Responses to Comments on the Final Environmental Impact Statement

The Final Environmental Impact Statement (EIS) for the Los Angeles International Airport (LAX) Proposed Master Plan Improvements has been prepared pursuant to the National Environmental Policy Act (NEPA), and in accordance with the Council on Environmental Quality (CEQ) implementing regulations (40 CFR part 1500-1508), and FAA Order 5050.4A, *Airport Environmental Handbook*.

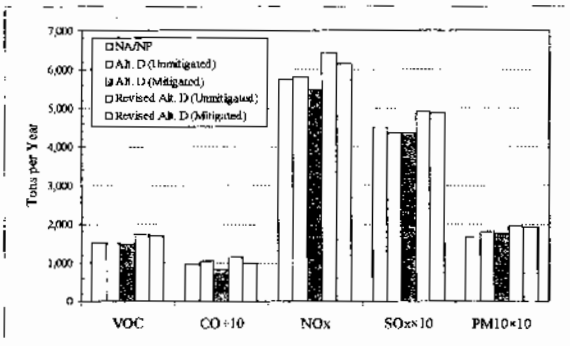
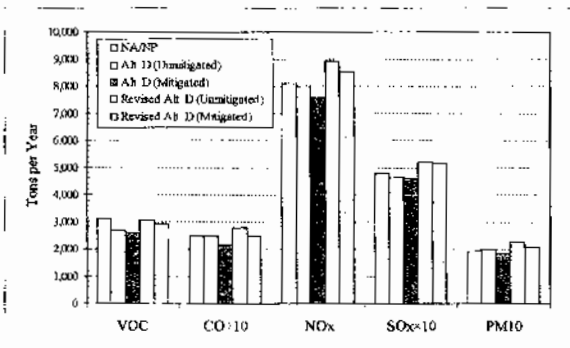
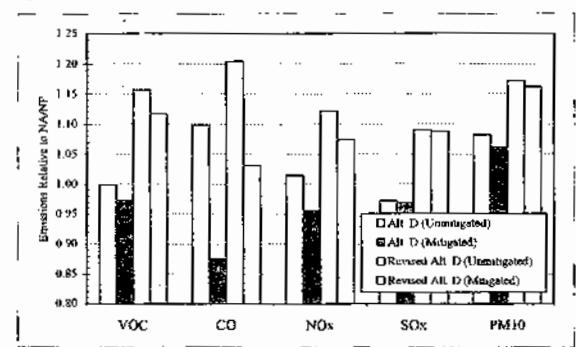
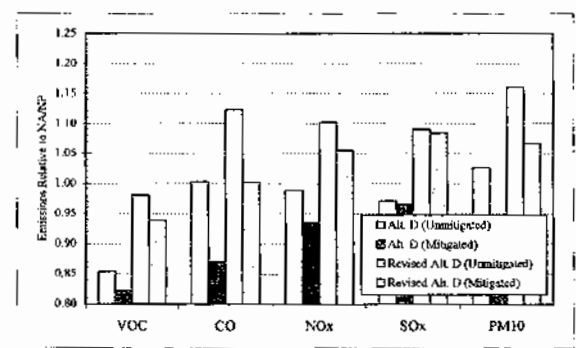
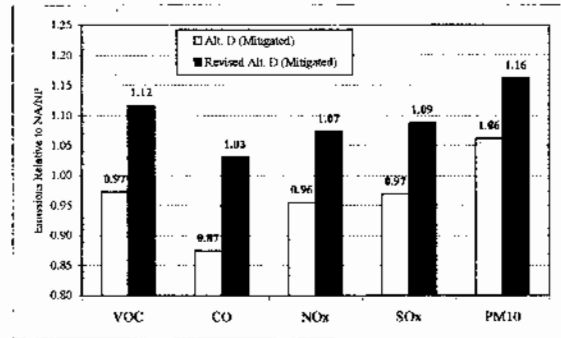
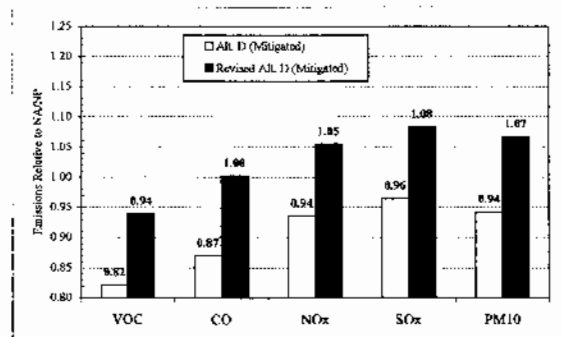
After modeling the emissions impacts of Revised Alternative D, even with the assumptions underlying the NA/NP Alternative and its projected emissions impacts held constant, the results are startling. First, as indicated in Table 2 and Figures 1 through 6, mitigated emissions under the Revised Alternative D increase from 4% to 18% less than emissions under the NA/NP Alternative (depending on the specific emissions species considered) to as much as 8% more than emissions under the NA/NP Alternative. Only emissions of VOC continue to be lower than emissions under the NA/NP Alternative - emissions of CO, NO_x, SO_x, and PM₁₀ are all higher than those of the NA/NP Alternative. As illustrated in Figures 7 and 8 in Attachment 1, mitigated emissions under Revised Alternative D are equal to or higher than those of emissions from mitigated Alternative C for on-airport sources, and only 1% to 12% lower than mitigated Alternative C for all sources (as compared to 12% to 22% lower for Alternative D compared to Alternative C in the FEIS). Thus, the sensitivity of emissions and air quality impacts to aircraft activity levels (and the presumed gate constraints) is obvious. Note that while the Tables and Figures presented only illustrate emissions relationships in the year 2015, the same relationships would carry through to influence interim year emissions estimates and the air quality.

As indicated in Table 2 and Figures 1 through 6, mitigated emissions under the revised alternative emissions D shift from a state of being 4-18 percent less than emissions under the NA/NP (depending on the specific emissions species considered) to a state where they are as much as 8 percent more than emissions under the NA/NP. Only emissions of VOC continue to be lower than emissions under the NA/NP - emissions of CO, NO_x, SO_x, and PM-10 are all higher than those of the NA/NP. As illustrated in Figures 7 and 8, mitigated emissions under revised alternative D are equal to or higher than those of mitigated alternative C for on-airport sources and only 1-12 percent lower than mitigated alternative C for all sources (as compared to 12-22 percent lower as alternative D is analyzed in the FEIS). Thus, the sensitivity of emissions and air quality impacts to aircraft activity levels (and the presumed gate constraints) is obvious. Note also, that while the tables and figures presented below only illustrate emissions relationships in 2015, the same relations would carry through to influence interim year emission estimates and air quality.

Figure 1. On-Airport Emissions in 2015 (tons per year)

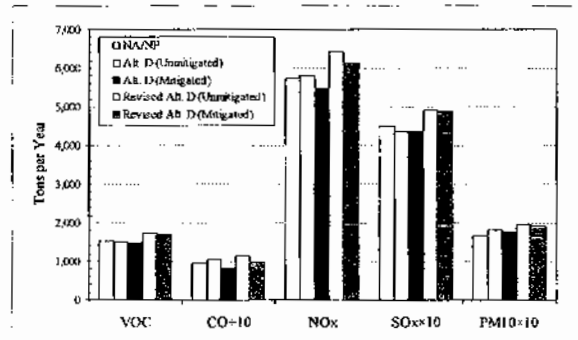
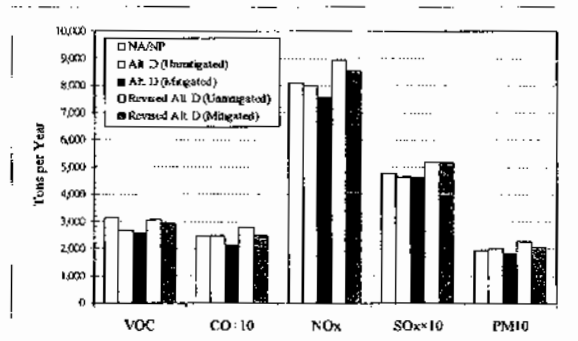
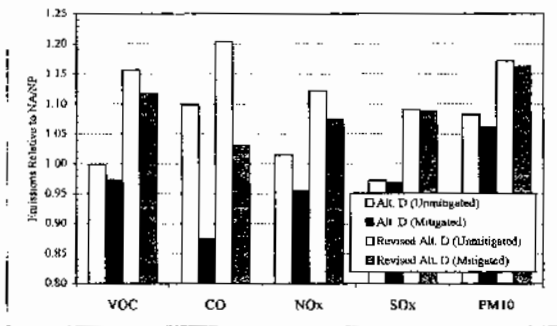
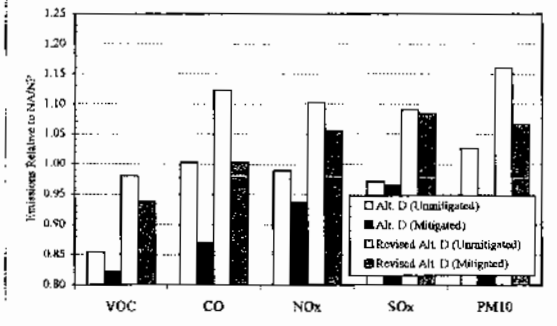
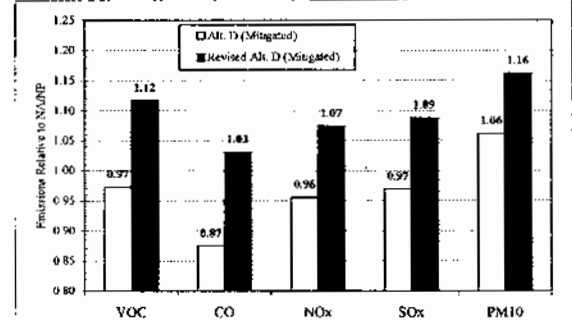
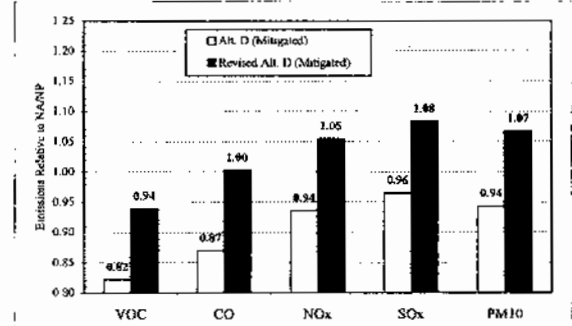
As indicated in Table 2 and Figures 1 through 6, mitigated emissions under the revised alternative D shift from a state of being 4-18 percent less than emissions under the NA/NP (depending on the specific emissions species considered) to a state where they are as much as 8 percent more than emissions under the NA/NP. Only emissions of VOC continue to be lower than emissions under the NA/NP - emissions of CO, NO_x, SO_x, and PM-10 are all higher than those of the NA/NP. As illustrated in Figures 7 and 8, mitigated emissions under revised alternative D are equal to or higher than those of mitigated alternative C for on-airport sources and only 1-12 percent lower than mitigated alternative C for all sources (as compared to 12-22 percent lower as alternative D is analyzed in the FEIS). Thus, the sensitivity of emissions and air quality impacts to aircraft activity levels (and the presumed gate constraints) is obvious. Note also, that while the tables and figures presented below only illustrate emissions relationships in 2015, the same relations would carry through to influence interim year emission estimates and air quality.

Figure 7. On-Airport Mitigated Emissions in 2015 Relative to Alt. C

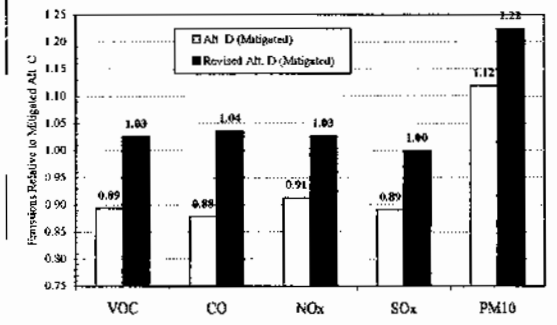
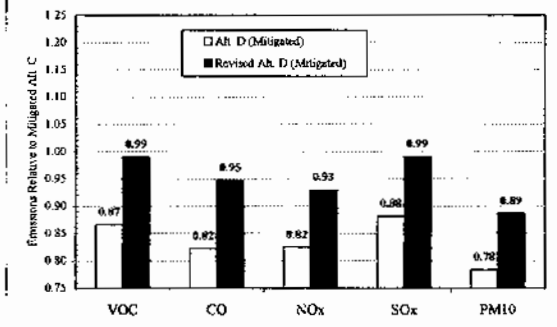
continue to be lower than emissions under the NA/NP Alternative - emissions of CO, NO_x, SO_x, and PM₁₀ are all higher than those of the NA/NP Alternative. As illustrated in Figures 7 and 8 in Attachment 1, mitigated emissions under Revised Alternative D are equal to or higher than those of emissions from mitigated Alternative C for on-airport sources, and only 1% to 12% lower than mitigated Alternative C for all sources (as compared to 12% to 22% lower for Alternative D compared to Alternative C in the FRIS). Thus, the sensitivity of emissions and air quality impacts to aircraft activity levels (and the presumed gate constraints) is obvious. Note that while the Tables and Figures presented only illustrate emissions relationships in the year 2015, the same relationships would carry through to influence interim year emissions estimates and the air quality.
